APPLICATION FOR PERMISSION UNDER SECTION 16 OF THE TOWN PLANNING ORDINANCE (CAP. 131)

(a) Proposed use(s)/development 擬議用途/發展	Proposed Temporary Open Storage of Construction Materials and Vehicles and Associated Filling of Land for a Period of 3 Years (Please illustrate the details of the proposal on a layout plan) (請用平面圖說明擬議詳情)

(S.16 Planning Application No. A/YL-SK/426)

Departmental Comments		Applicant's Responses
1. Comments of the District Planning Officer/Fanling, Sheung Shui and Yuen Long East, Planning Department (DPO/FSYLE, PlanD) (Contact Person: Mr. David CHENG; Tel:)

FIGURE 3

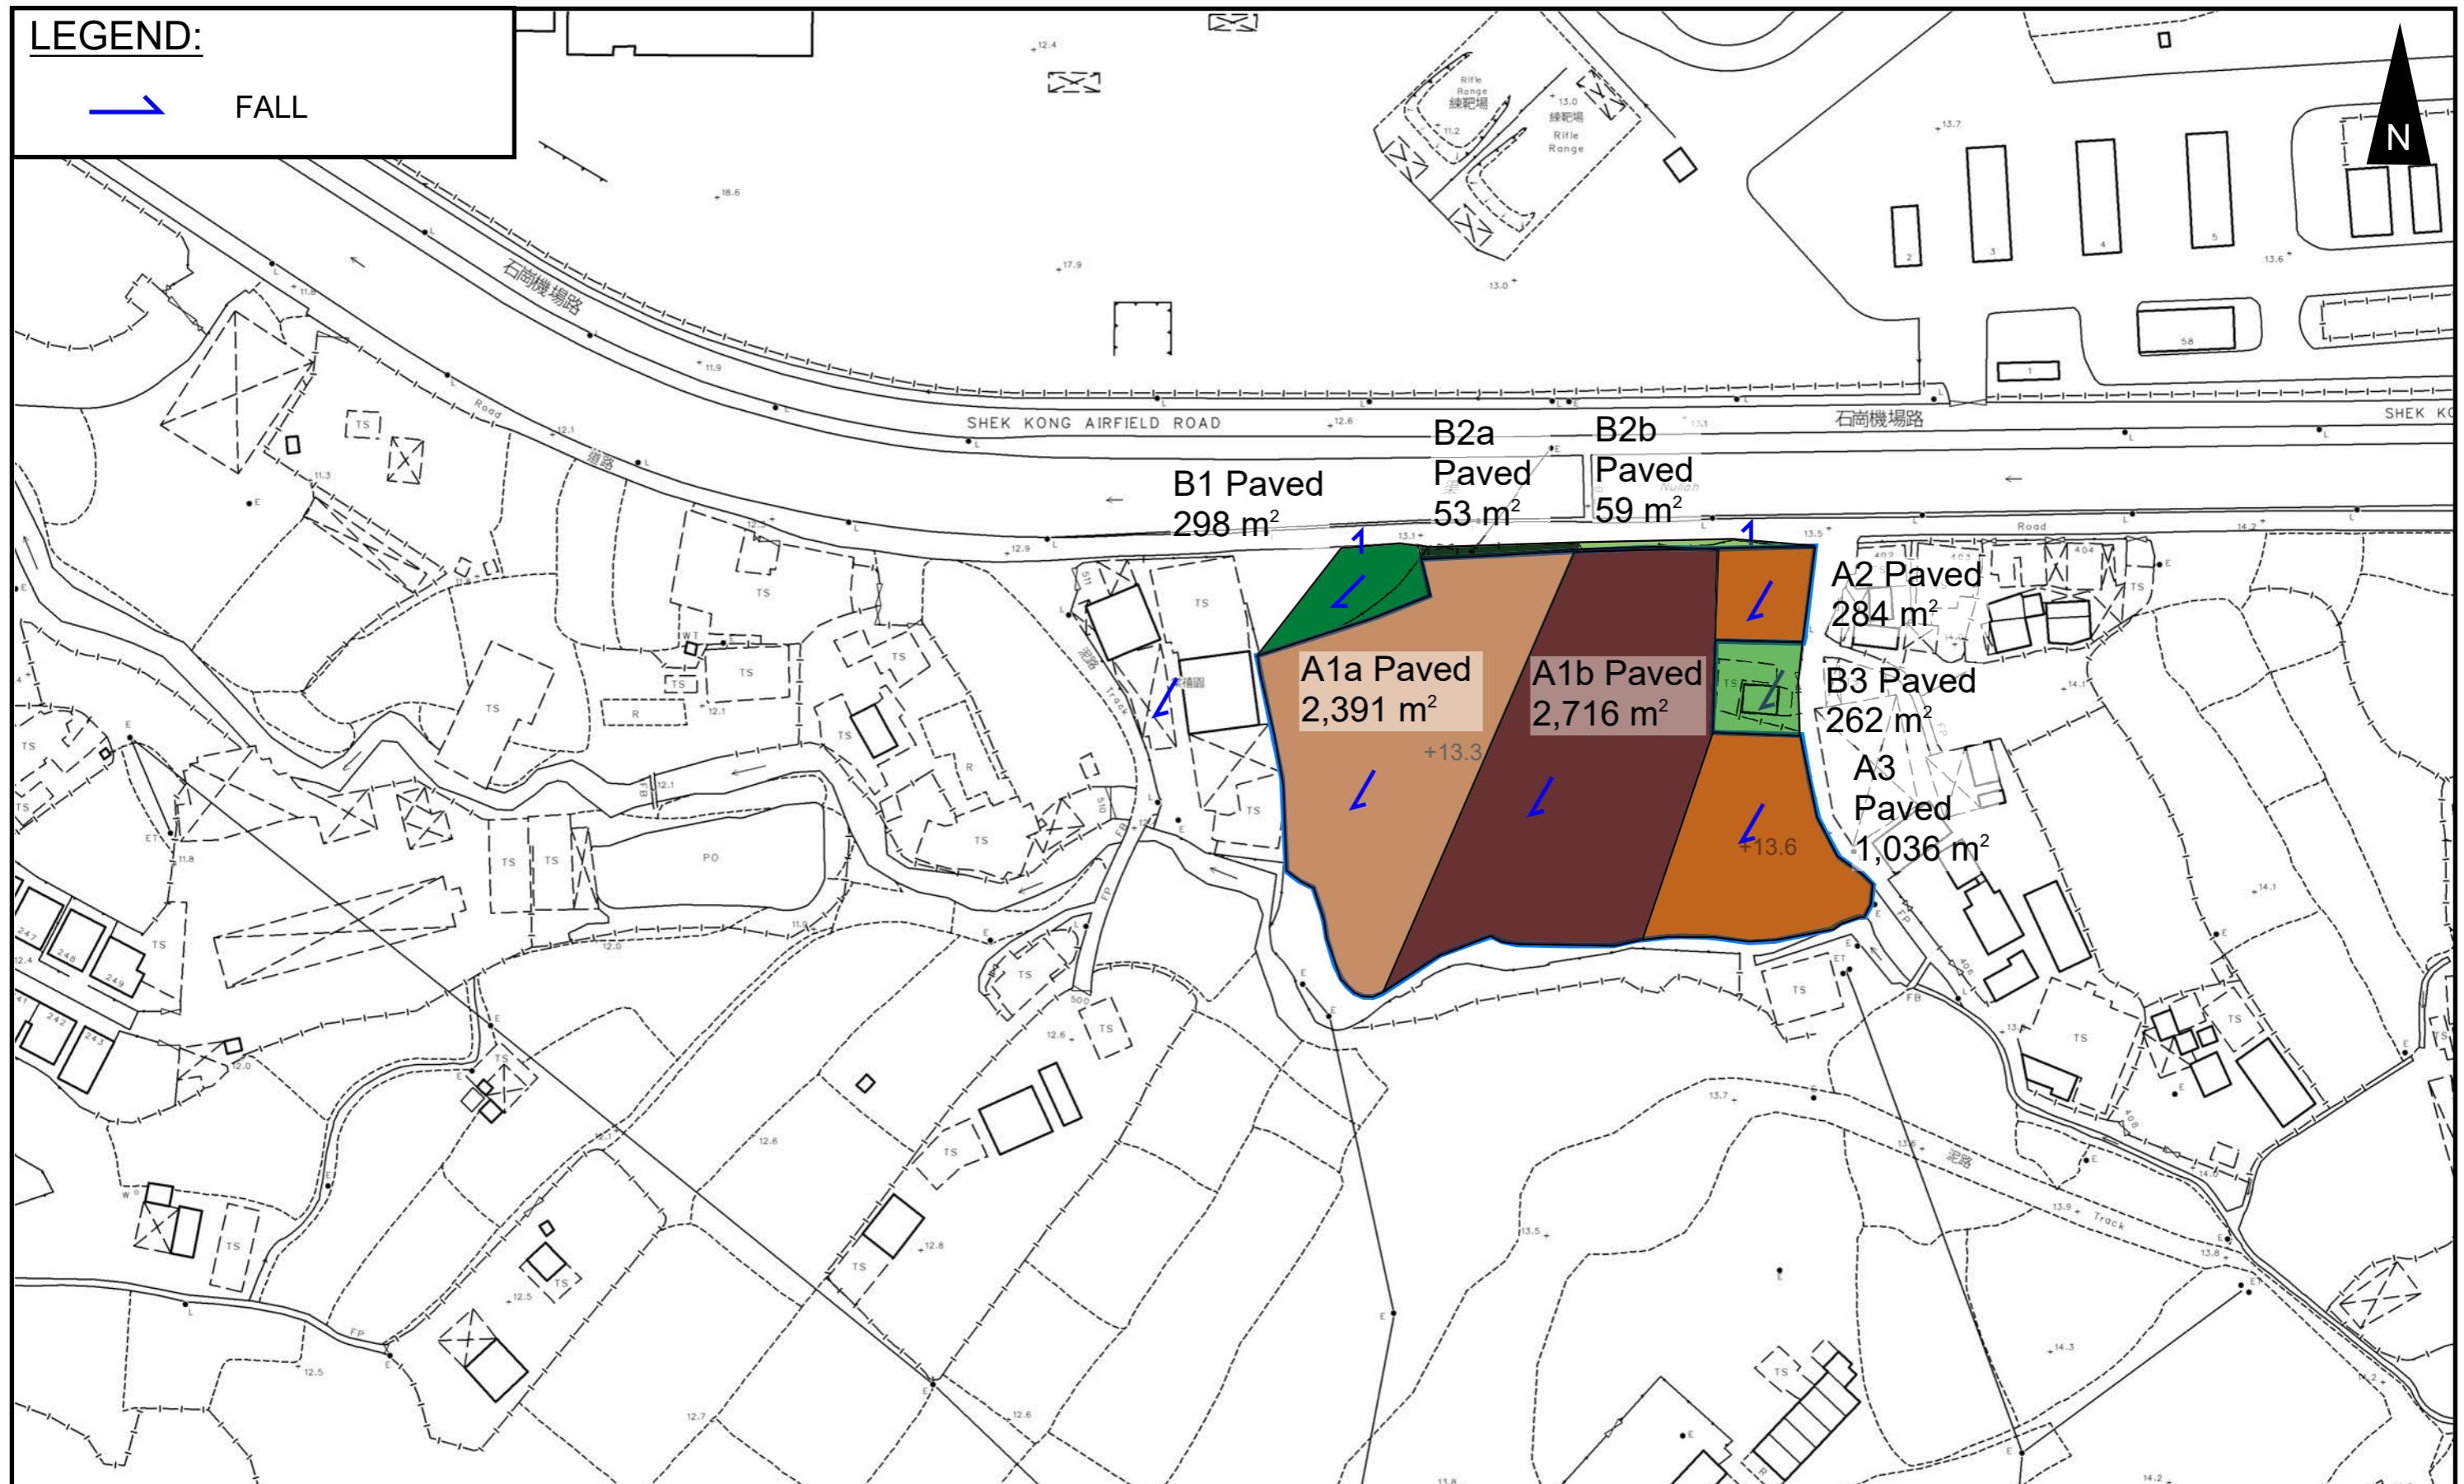
(c) The size of the proposed channels between CP2 03 to CP1 05 is 600mm. For consistency, please revise the size of the channels between CP1.05 to existing watercourse to 600mm.	Noted. Channel sizes are revised accordingly.

**FIGURE NUMBER
FIGURE 5**

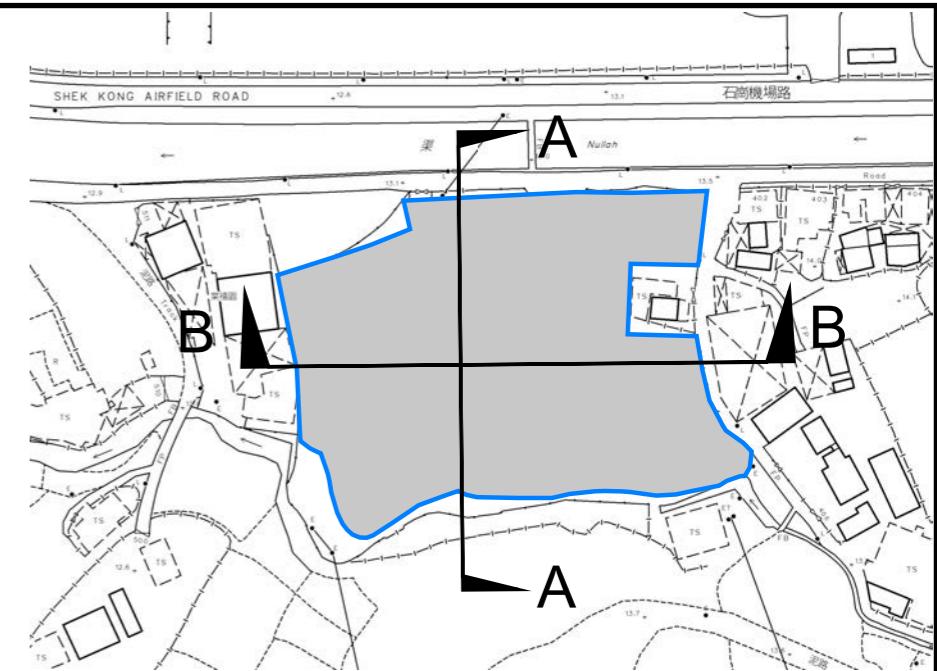
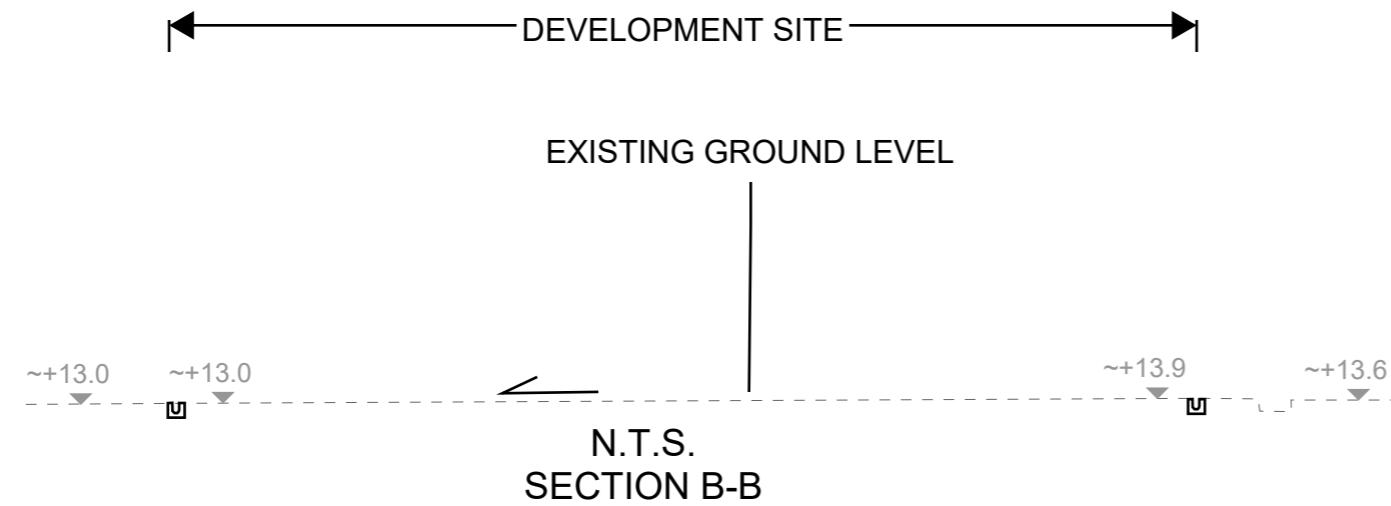
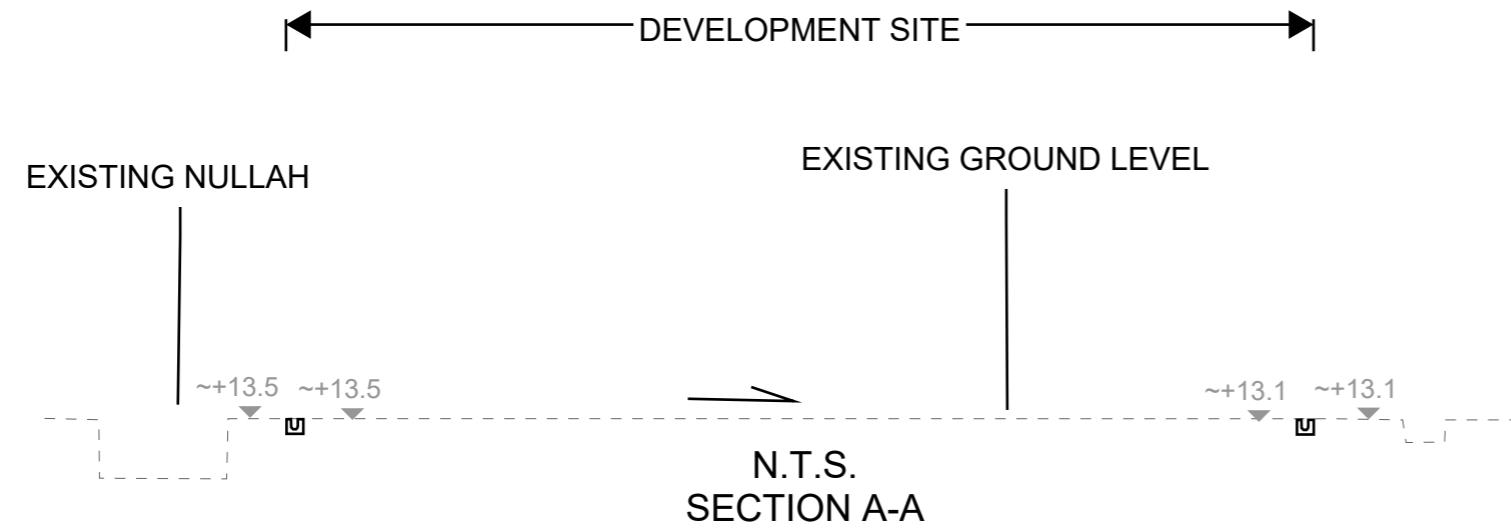
(d)	<p>The existing and proposed ground levels showed in the cross sections are not tally with the levels showed in the drainage schedule. The cross sections should be extended to show the ground levels of the adjacent areas.</p>	<p>Noted. The sections in Figure 5 are updated for your perusal.</p>
-----	---	--
